Modification of Minister's Approval

Application Number: MP10_0165

The Land: Lot 6 DP 260000, Lot 3 DP 25688 & Lot 4 DP25688
5 Whiteside Street and 14 and 16 David Avenue, North Ryde

Modification: **MP 10_0165 MOD 1:** the modification includes:

Figure 1: Revised Building Envelope – Building A

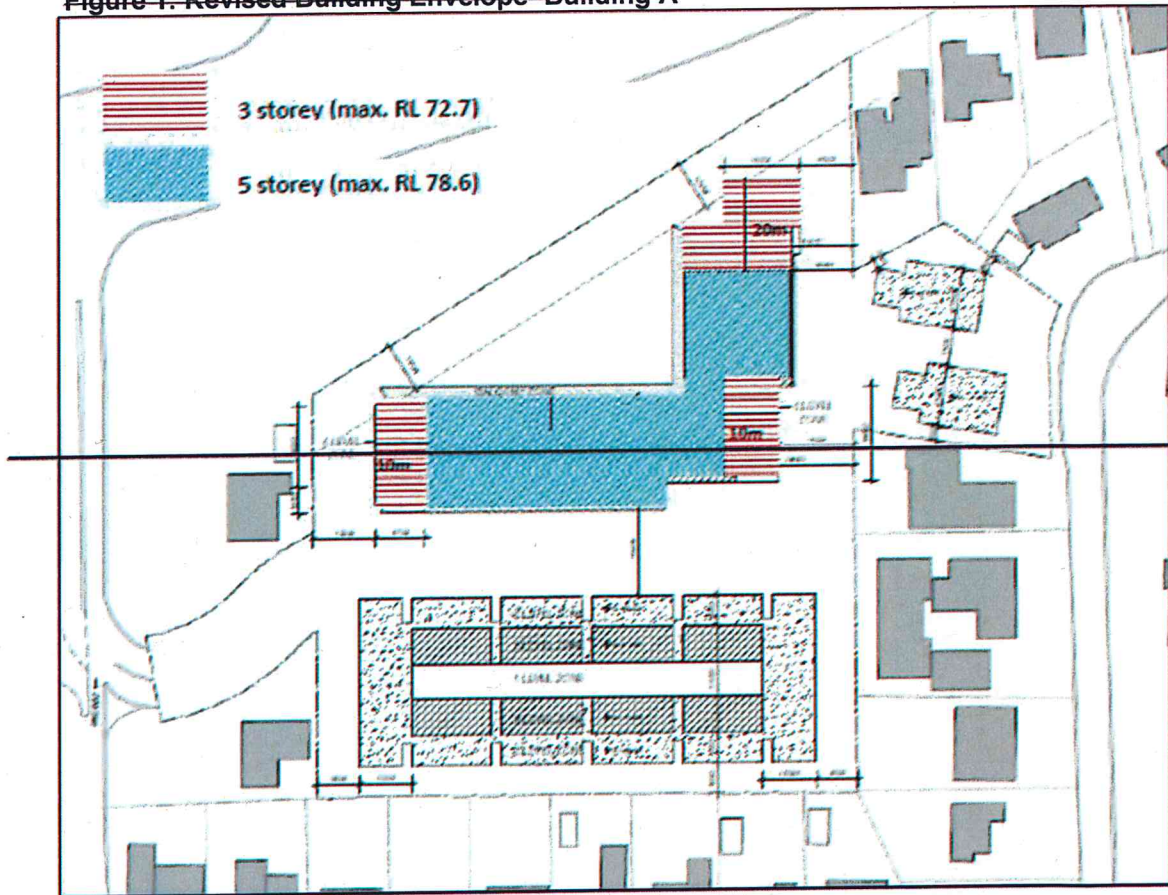
- (f) Schedule 2 Part B - Modification B1 is deleted by the ~~bold struck out~~ words/numbers as follows:

~~B1 – BUILDING ENVELOPE HEIGHT MODIFICATIONS~~

~~The building heights shown on 'Envelope Plan' DA-04 prepared by SJB Architects and referred to in condition A2 shall be modified as follows:~~

- ~~a) the building envelope for Building A (fronting Epping Road) shall be reduced to 3 and 5 storeys (maximum RLs 72.2, and 78.6, respectively) as illustrated in Figure 1 below, excluding any plant, lift overruns, or similar projections). Drawings indicating heights to AHD shall be provided with the future application/s.~~
